State of Alaska  
Department of Fish and Game  
Sportfish Division

Nomination Form  
Fish Distribution Database

Nomination # <u>07-238</u>	ADF&G Fisheries Scientist	Date
Revision Year: <u>2006</u>		
Revision to: Atlas <input type="checkbox"/> Catalog <input type="checkbox"/>	ADNR OHMP Operations Mgr.	Date <u>10/29/07</u>
Both <input type="checkbox"/>	<i>[Signature]</i>	Date
Revision Code: <u>F-2</u>	FDD Project Biologist	Date
	Cartographer	Date

SUBJECT: Transmittal Letter for Nomination to Delete a Portion of Ship Creek from the Atlas and Catalog of Waters Important for Spawning, Rearing or Migration of Anadromous Fishes

# Stream 102-70-10320 Nomination Correction Craig C-2, T.72E, R.85, S.10

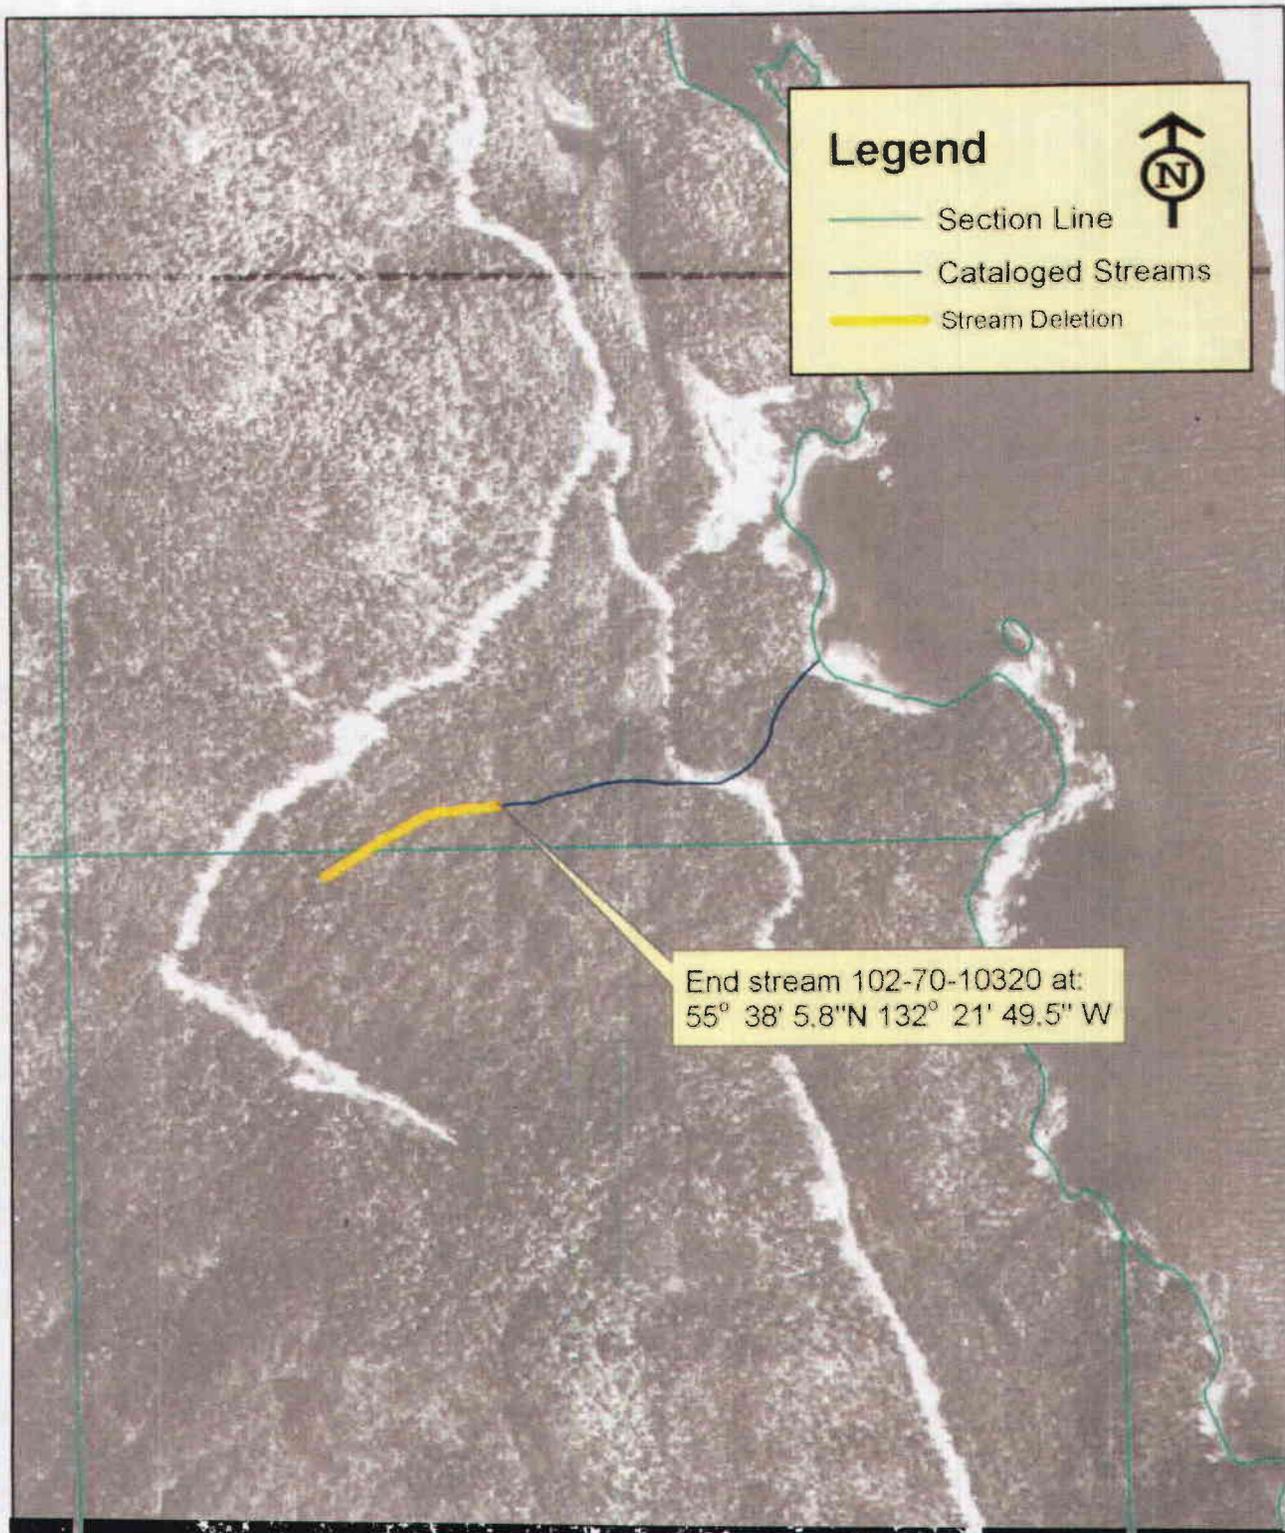
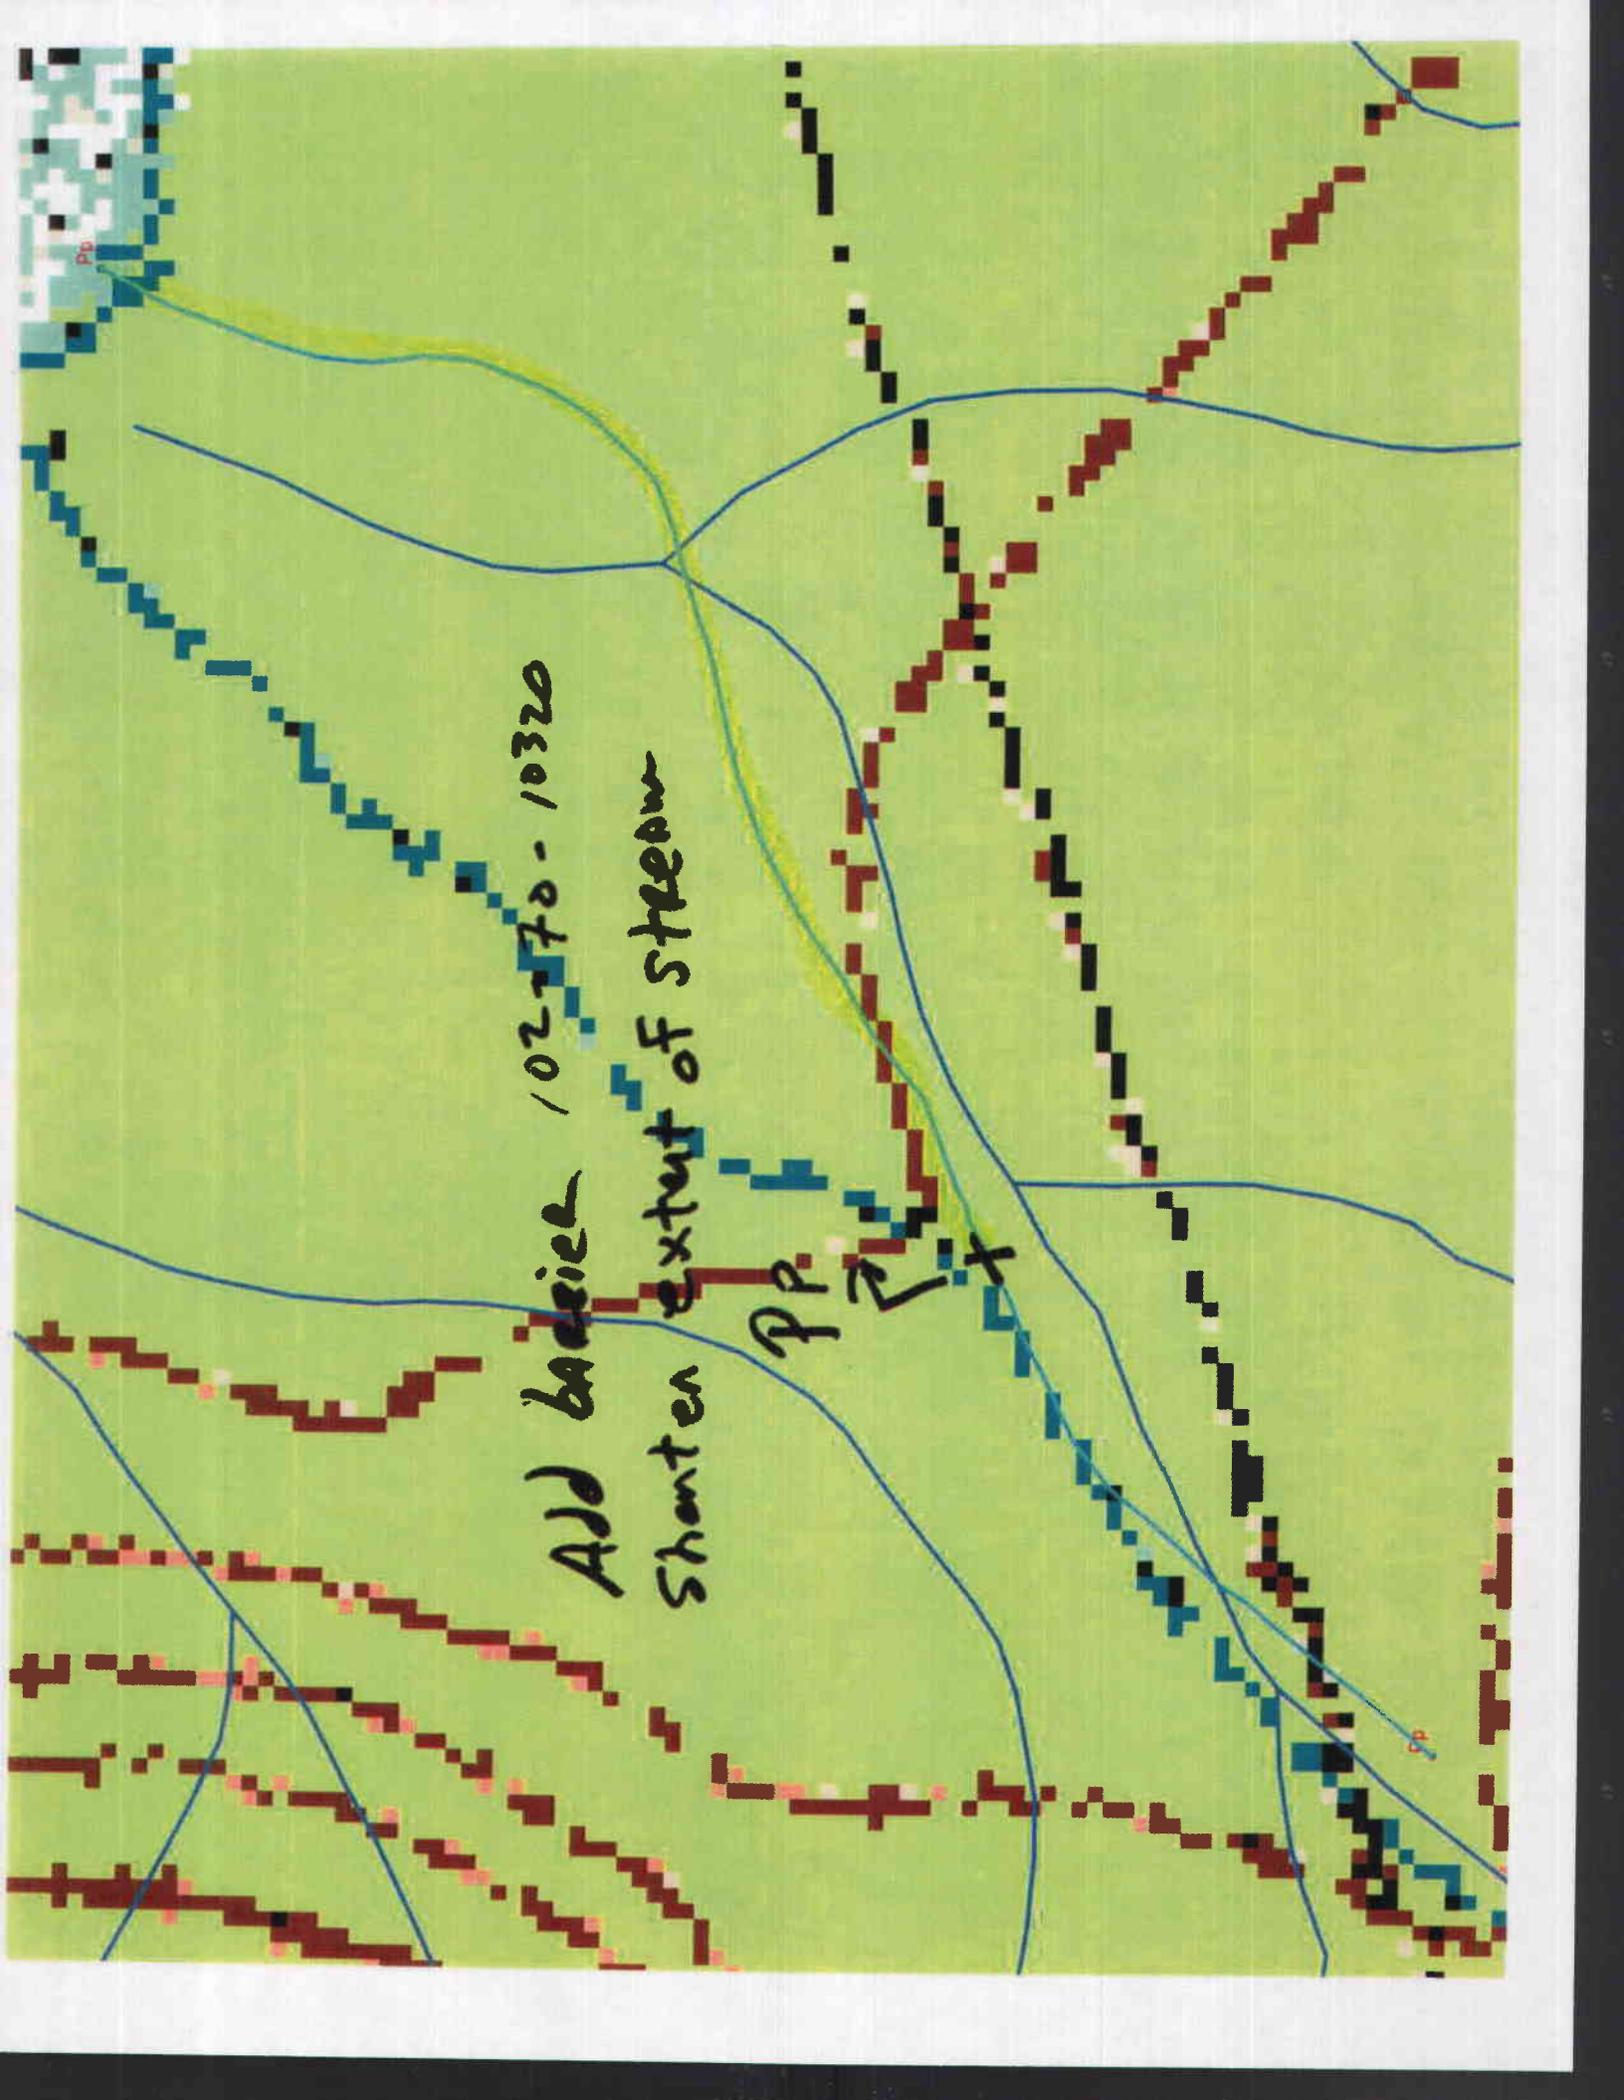
**Action:** Remove the upstream portion of stream 102-70-10320 up to 55° 38' 05.8" N 132° 21' 49.5" W.

Add Fish barrier

~12' Falls bedrock step above & below

George Inlet

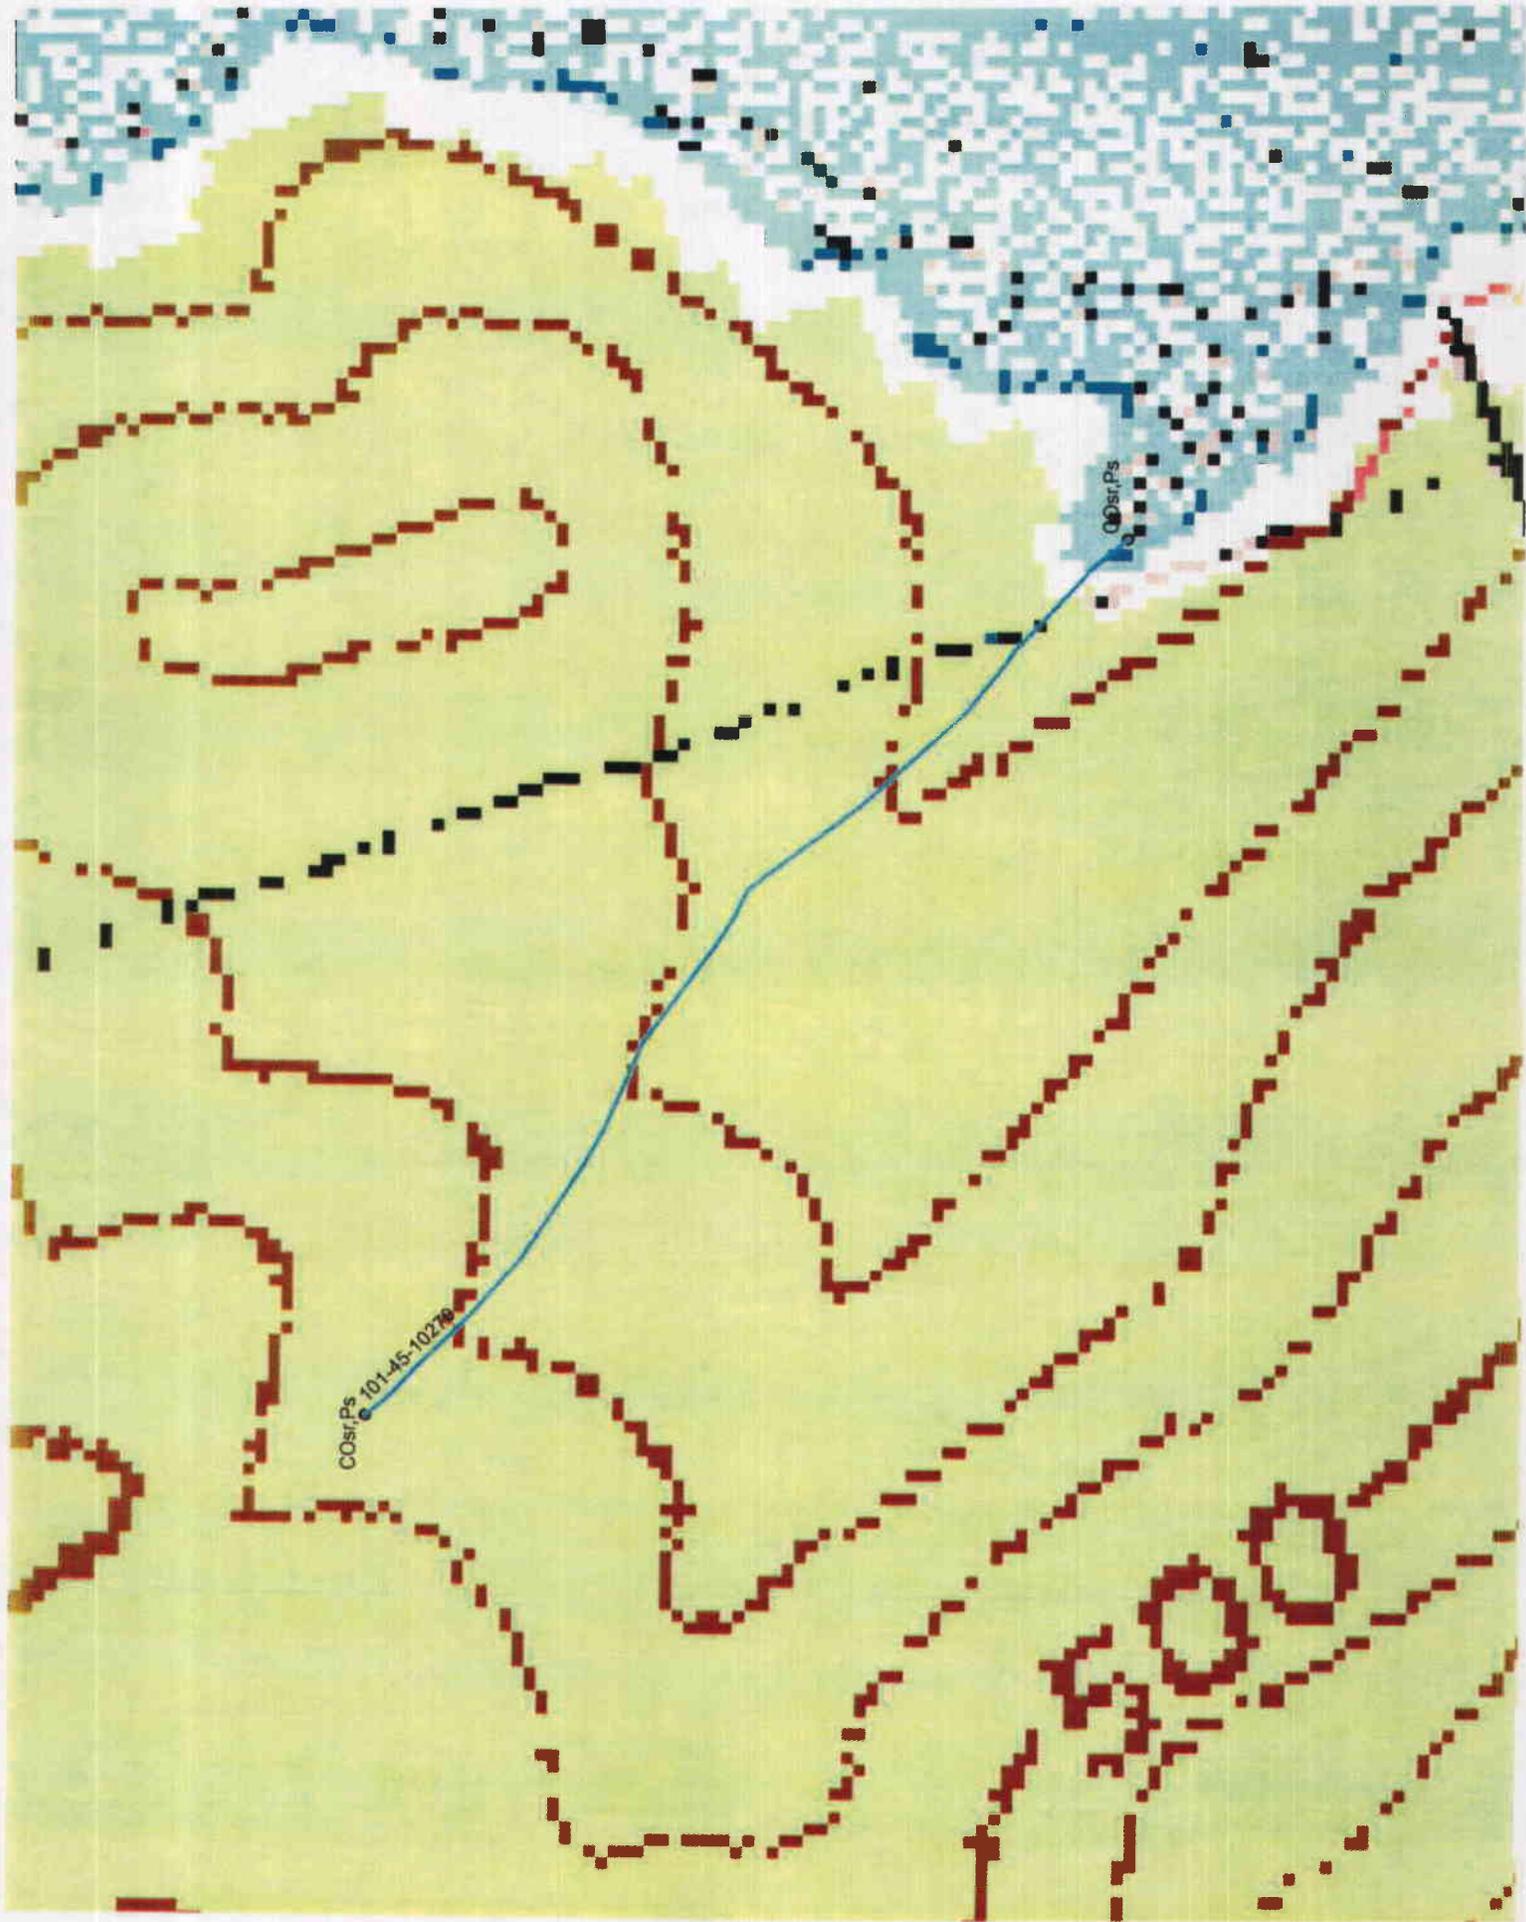
**Action:** Remove the upstream segment of 101-45-10270, 150 feet upstream of GPS Point 133.52597 W, 55.49147 N.

Original nomination 83-613 indicates extent to approximate location of barrier. No data to indicate extent far. Shorten stream add barrier

109-42-10050

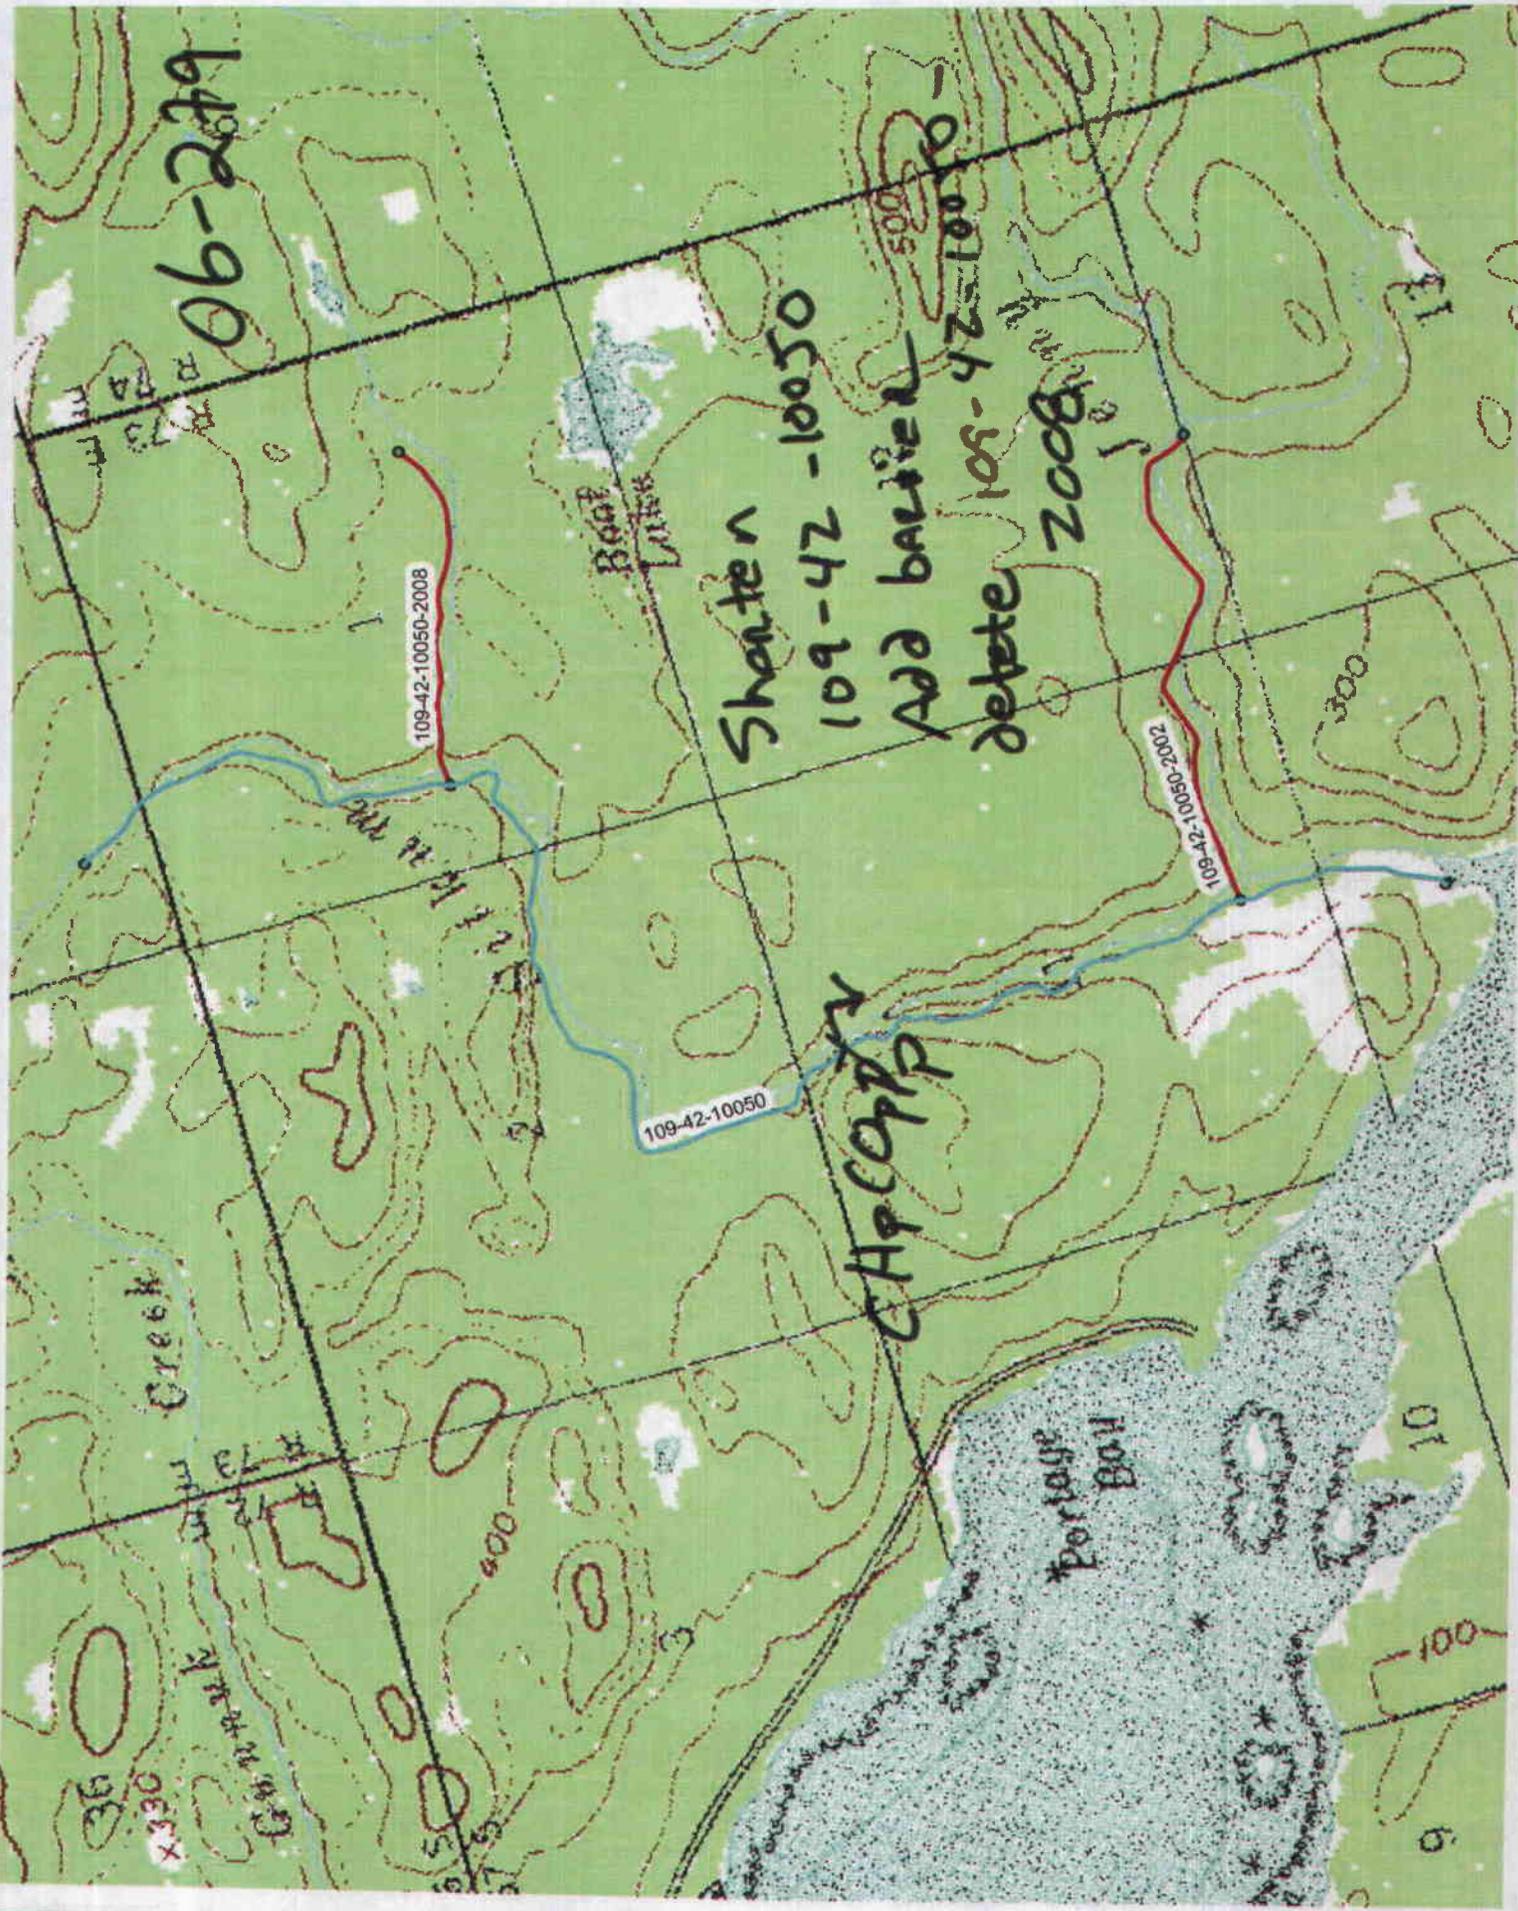
The location of the 15' barrier was confirmed on 6/5/06 during a forest practices inspection.  
 Shorten 109-42-10050 add barrier  
~~to~~ delete 109-42-10050-2008

Sherten  
109-42-10050  
Add barrier  
delete 109-42-10050-  
2008
